DEPARTMENT OF TRANSPORTATION

Contract #: 04-0120F4Cty: SF/ALA Rte: 80 PM: 13.2/13.9File #: 69.28**WELDING INSPECTION REPORT****Resident Engineer:** Pursell, Gary**Address:** 333 Burma Road**City:** Oakland, CA 94607**Report No:** WIR-012148**Date Inspected:** 14-Feb-2010**Project Name:** SAS Superstructure**OSM Arrival Time:** 700**Prime Contractor:** American Bridge/Fluor Enterprises, a JV**OSM Departure Time:** 1500**Contractor:** Zhenhua Port Machinery Company, Ltd (ZPMC), Changxing Island **Location:** Shanghai, China

SEG 9BW:

1) PP75-FB003-139 – 005.

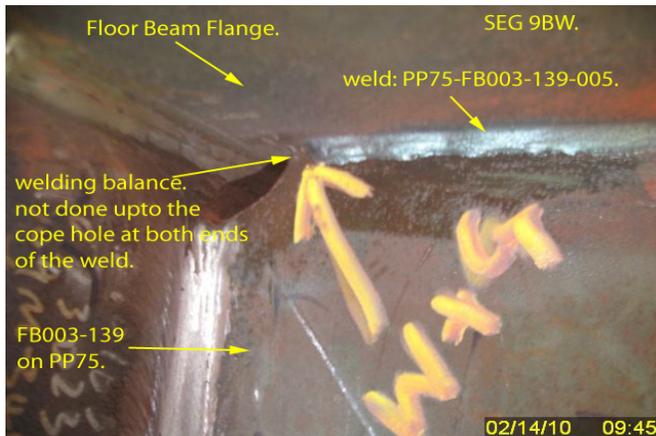
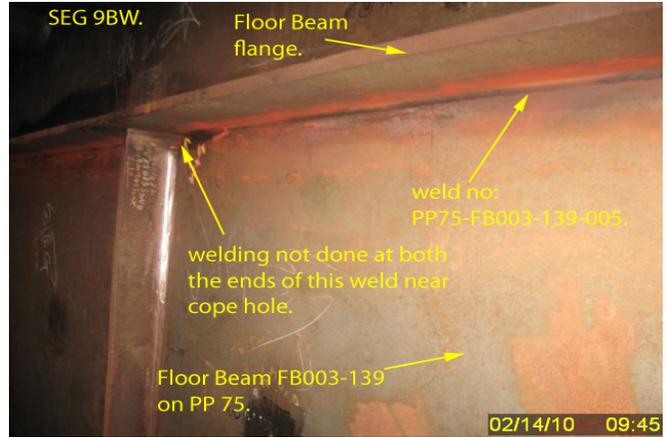
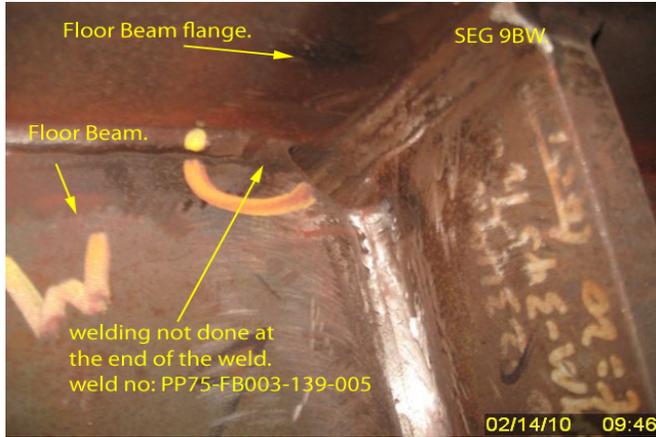
- Visually, this weld do not appeared to comply with the contract documents as the welding was not done completely at both the ends of the joint (i.e. at cope holes).

- The ends of this weld need to be welded and this location is clearly marked and identified on the weld.
